CORNFIELD ARROYO SECO SPECIFIC PLAN

**CORNFIELD ARROYO SECO SPECIFIC PLAN
FINAL ENVIRONMENTAL IMPACT REPORT**

RESPONSE TO COMMENTS

Figure 10-4
Cleanup Sites — Open and Closed Cases

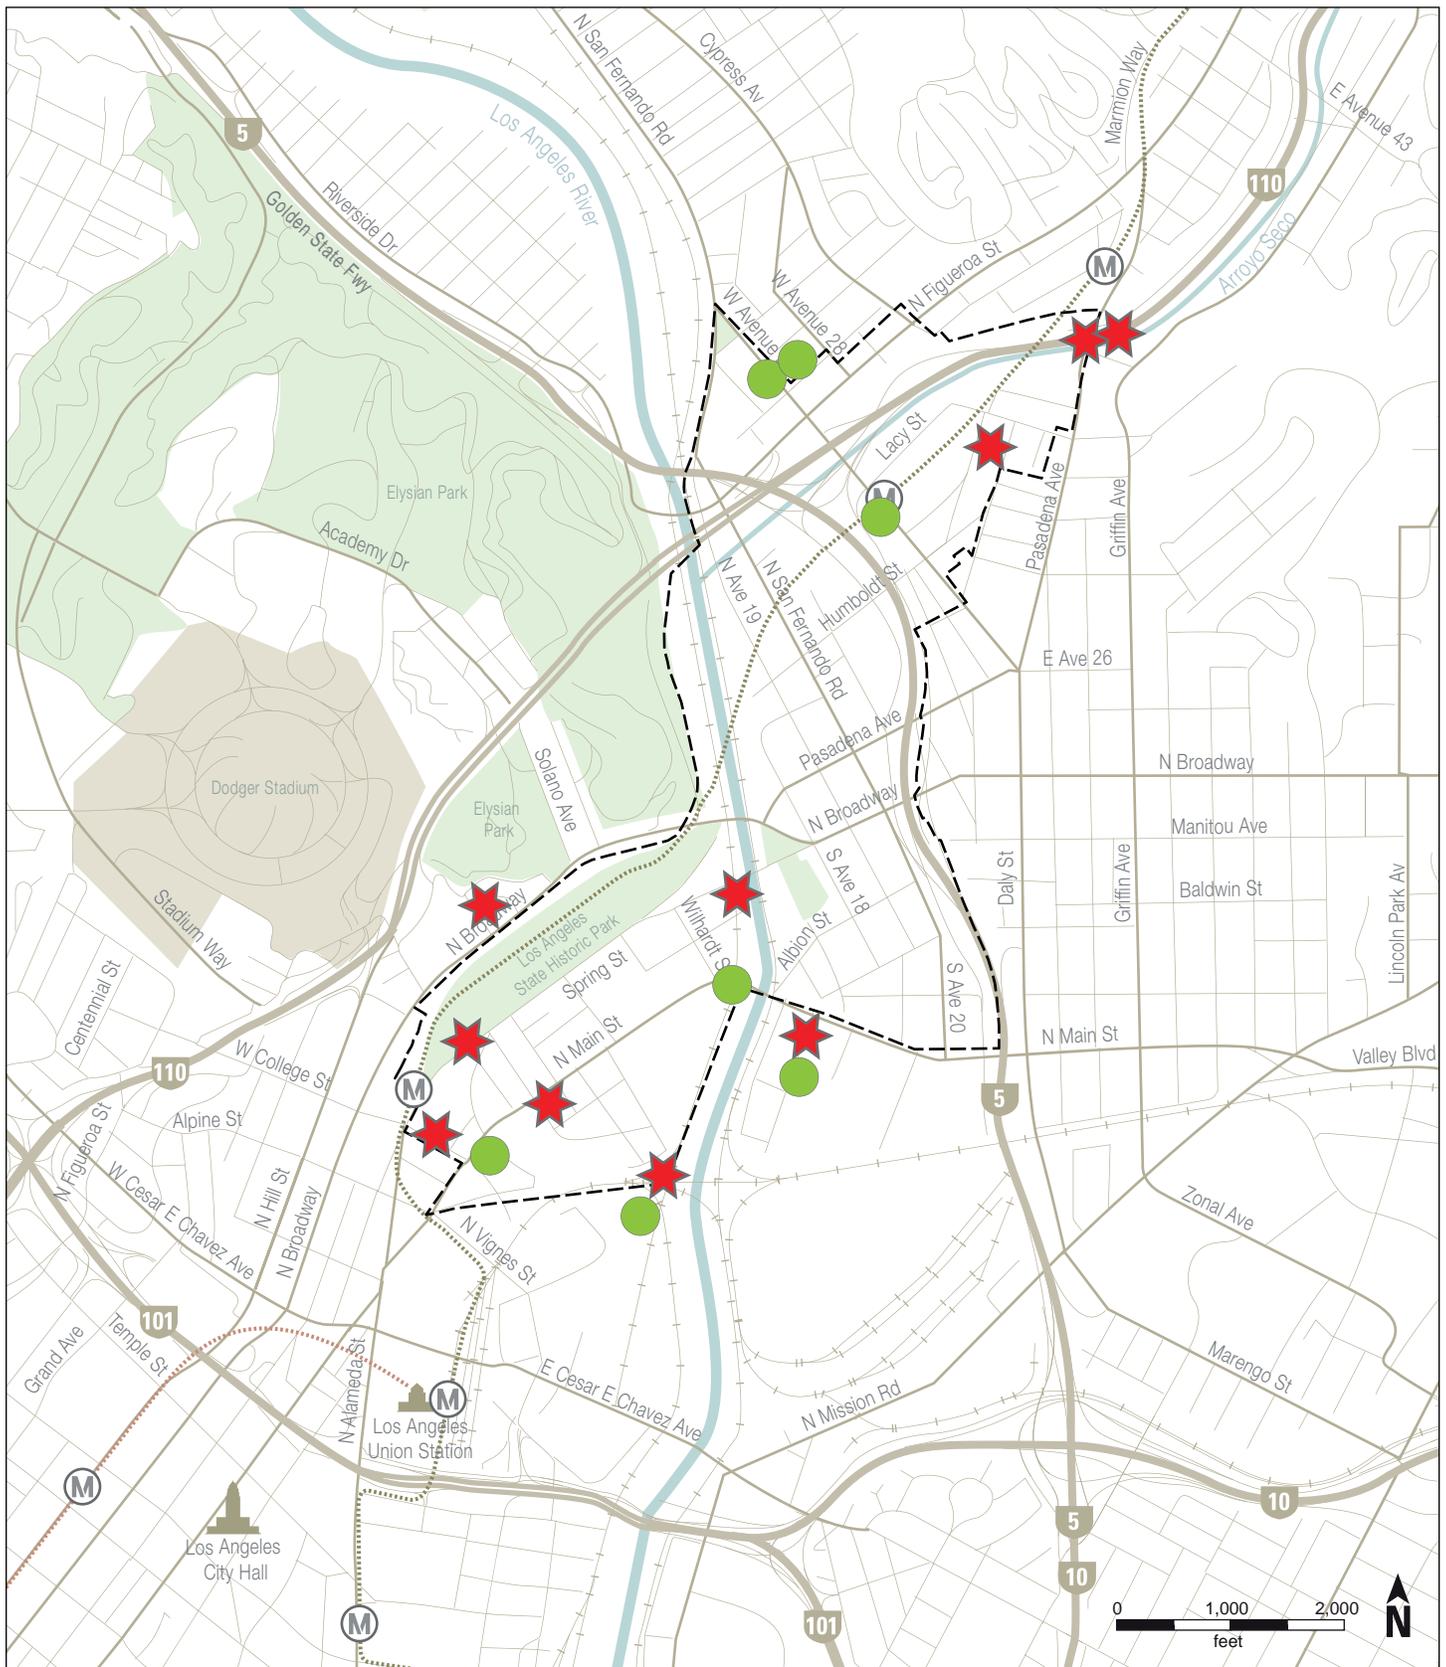
that shows the CERCLA sites within the Project Area. Figure 10-3 has been added to the EIR that shows the location of the two additional Cortese List sites. Figures 10-4 through 10-7 have been added to this FEIR that shows open and closed Cleanup Sites, Voluntary Cleanup Sites, oil and gas wells, and leaking (open and closed) and permitted Underground Storage Tanks (USTs) respectfully. The text has also been amended that updates the list of identified sites with contamination history and provides more clarity on the location of existing hazardous sites in relation to residential areas. See Corrections and Additions.

Figure 10-4 - shows those sites identified using the Geotracker Database that are either open or closed cases. The Geotracker database identifies sites that impact on groundwater.

Figure 10-6
Oil and Gas Wells

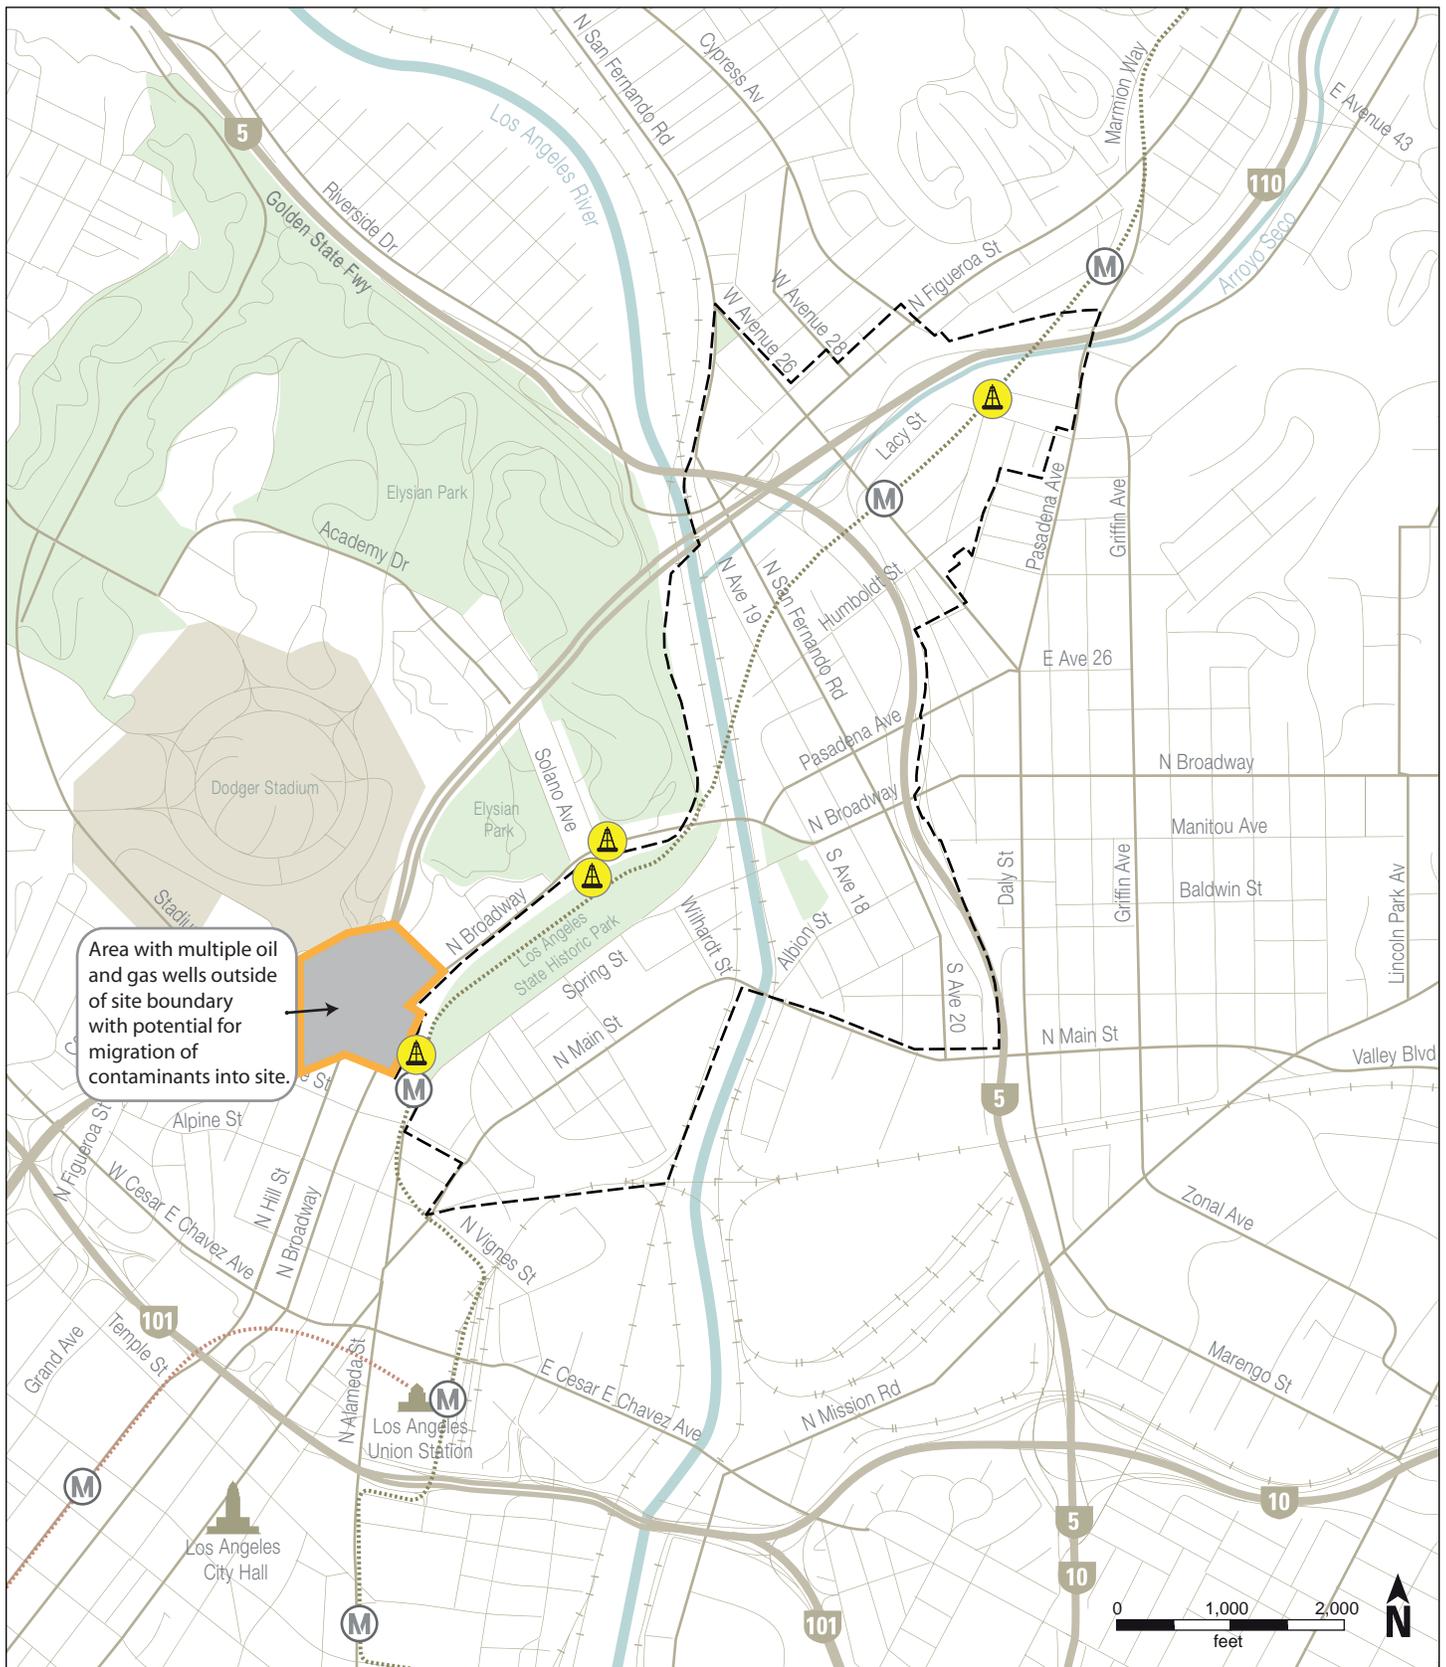
40-137 The comment states that the Original DEIR did not provide readily available DOGGR database. This EIR has been revised to include update on the locations of oil and gas wells. See Corrections and Additions for the revised text to 10.1.2.1B and Figure 10-6 in the Chapter 10, Hazardous Materials.

Review of the DOMMs database provided by the State of California Division of Oil and Gas Geothermal Resources (DOGGR), as accessed in April 2012, indicates that there are three mapped abandoned oil/gas wells within the Project Area boundary, with a further well located to the immediate north of the site off North Broadway. See Figure 10-6.

There is a significant cluster of wells located to the immediate west of the Project Area (in excess of 200 wells), but not within the Project Area boundary. See Figure 10-6. Although located outside of the Project Area, this cluster of wells has the potential to impact of the soil and groundwater quality beneath the site with the migration of contaminants into the site area through groundwater flow towards the Los Angeles River (i.e., beneath south western part of site). Mitigation Measure Hazardous Materials 10 has been added to reduce impacts to future development from abandoned oil ad gas wells.

Figure 10-8
Schools with 1/4-mile Buffer

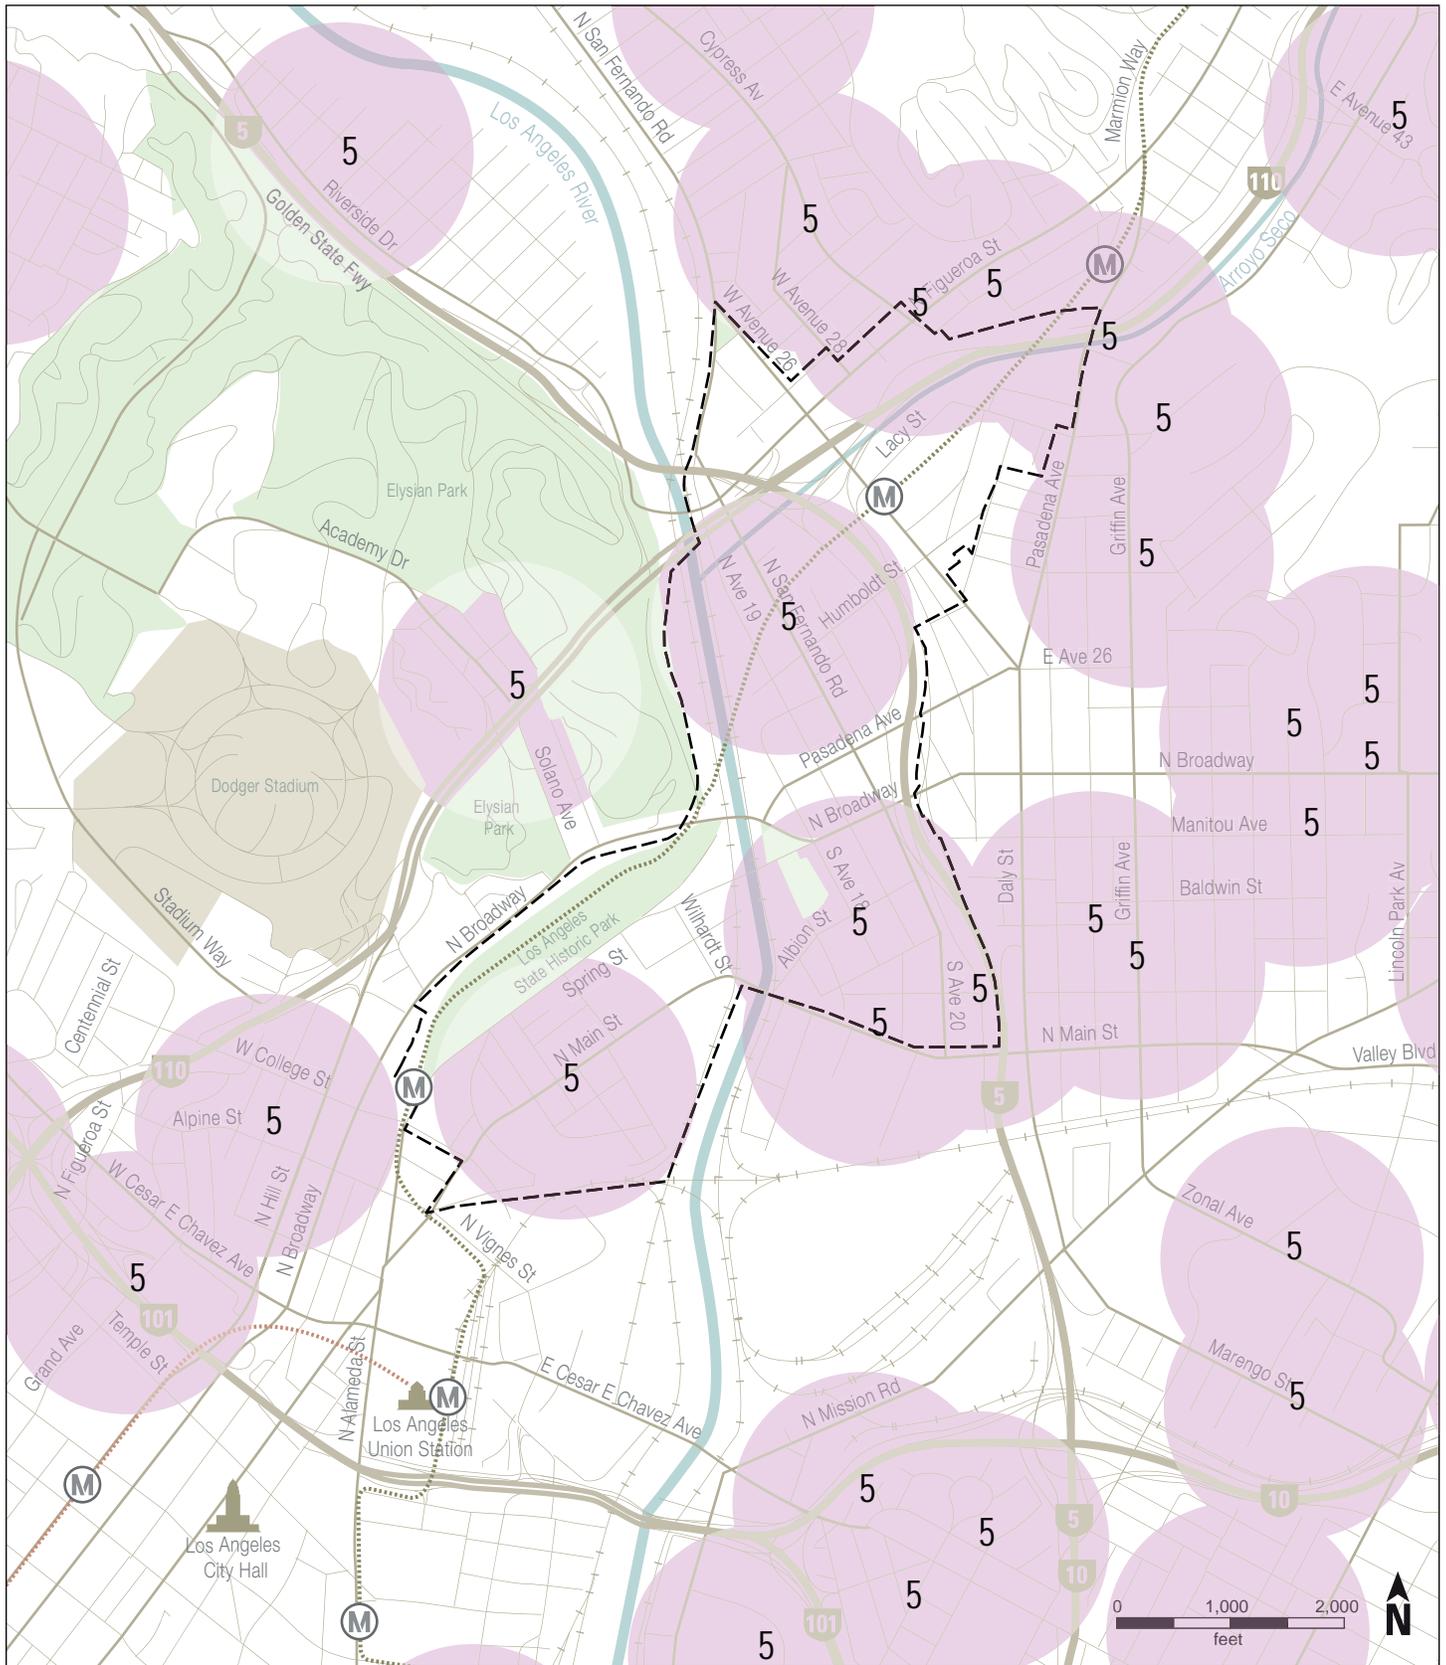
27-103 The comment states that the Original DEIR failed to specify compliance measures or standards for hazardous waste impacted sites within ¼ mile of schools. Comment is noted. Figure 10-8 has been added showing location of schools with ¼ mile buffer zones plotted around each school site. In addition, text has been revised to section 10.3.2.1 to indicate the amount of the project Area that would be within ¼ mile of a school. It is assumed that implementation of Mitigation Measures Hazardous Materials 3 will require that all hazardous materials and wastes are managed in compliance with City of Los Angeles, State and federal requirements. All compliance actions devised to remediate existing hazardous properties as referenced in Mitigation Measures Hazardous Materials 4, 8, 9, and 10 would also apply with the ¼ mile buffer area of an existing school. There, impacts would be less than significant. See Corrections and Additions.

Figure 10-8 – locates School premises within the site boundary or within close proximity, with a ¼ mile buffer zone plotted around each site.

Figure 12-1
Location of Sensitive Receptors
in the Vicinity of the Site
 Cornfield Arroyo Seco Specific Plan
 Final EIR
 August 10, 2012

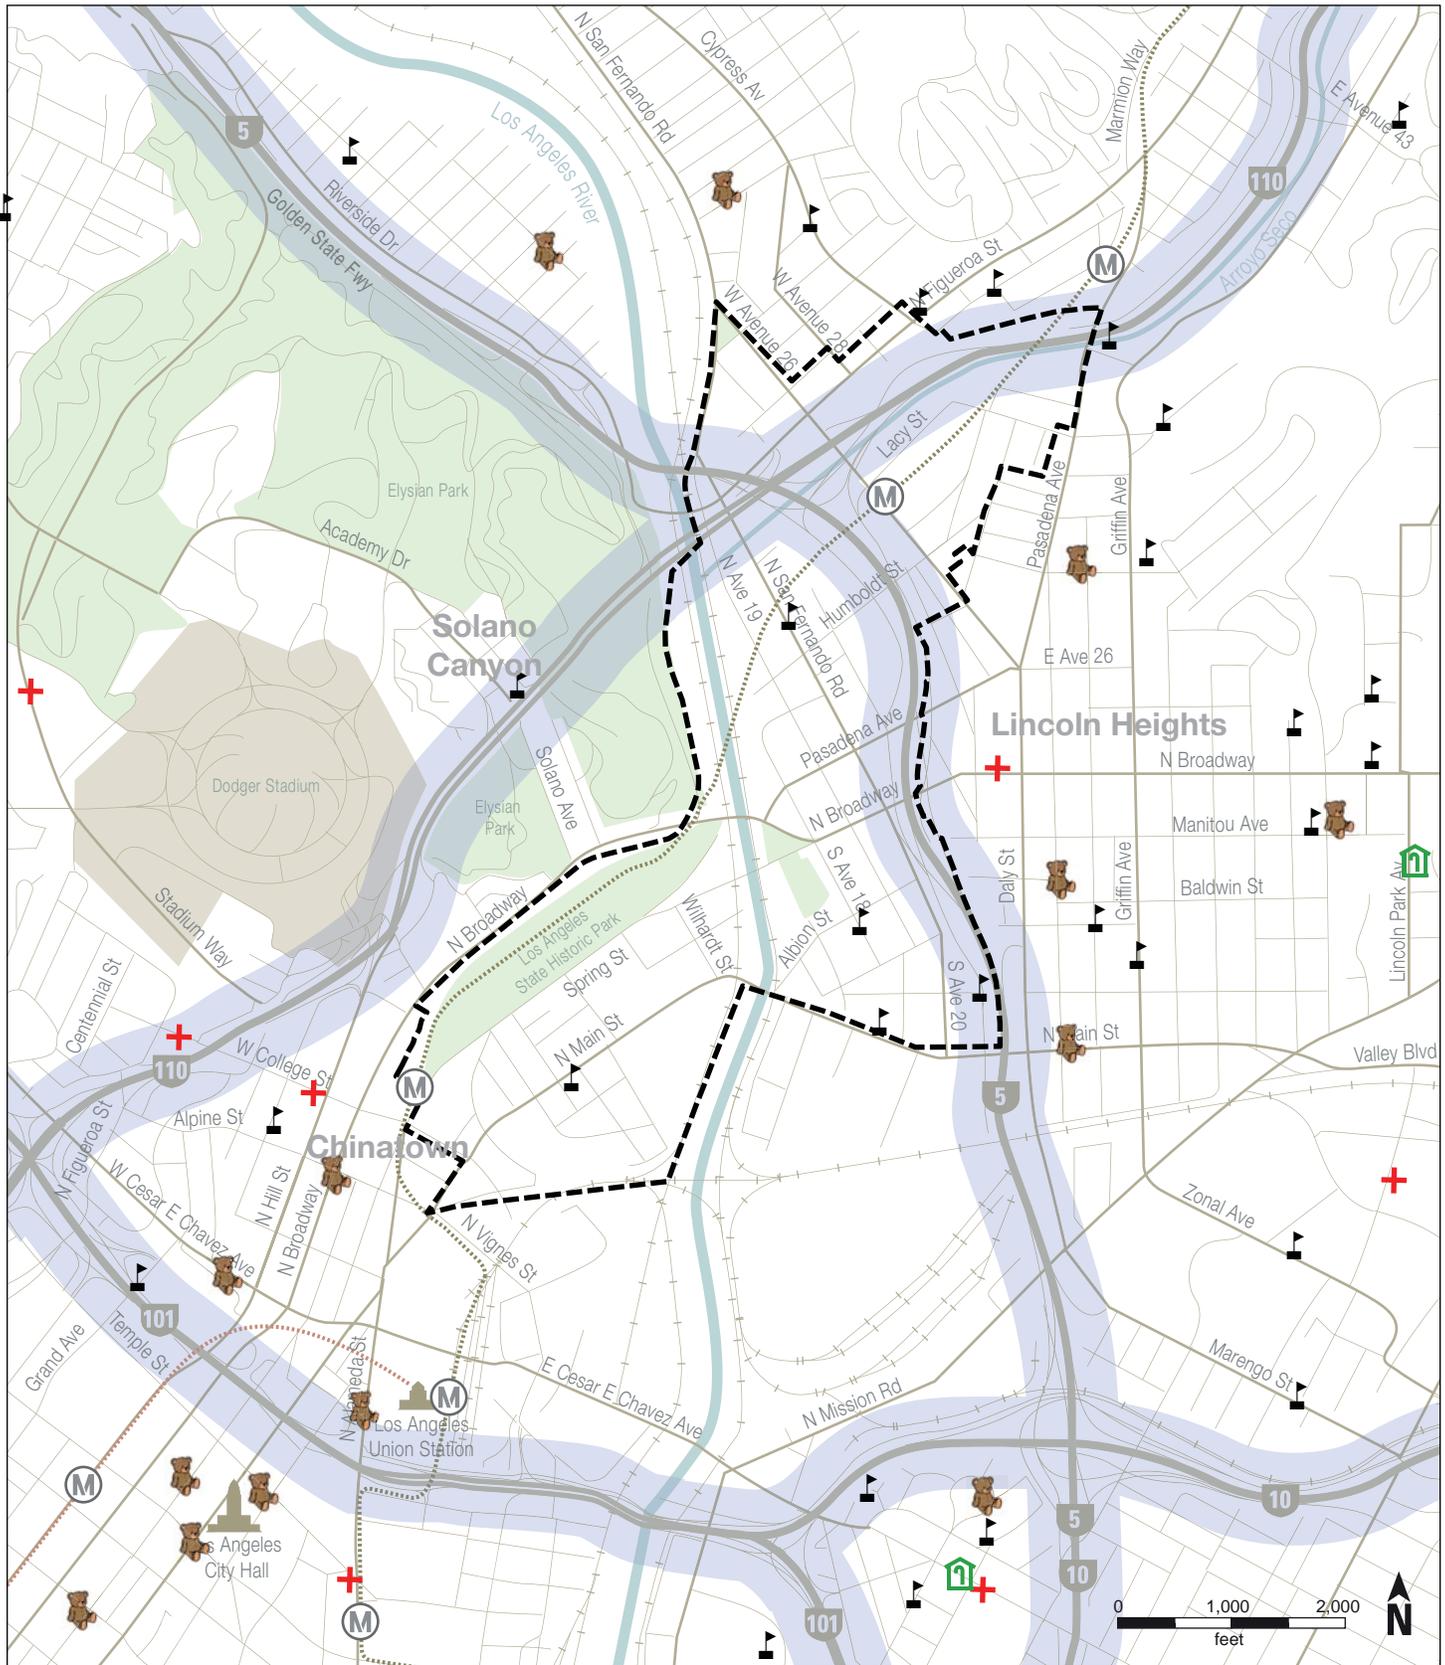
27-161 The comment identifies an inconsistency in the EIR, noting that the text in Chapter 14, Public Services, states that only two schools are in the Project Area yet Figure 12-1 depicts five schools. The text in Chapter 14, Section 14.1.4.1 refers only to the two LAUSD elementary schools while the additional schools reflected in Figure 12-1 include private schools in the area. The legend in Figure 12-1 has been corrected in Section 4, Corrections and Additions to reflect this.

Page 12-3, Figure 12-1, “School” in Legend is modified to “Public and Private Schools.” Figure is included in the figures section at the rear of this chapter.
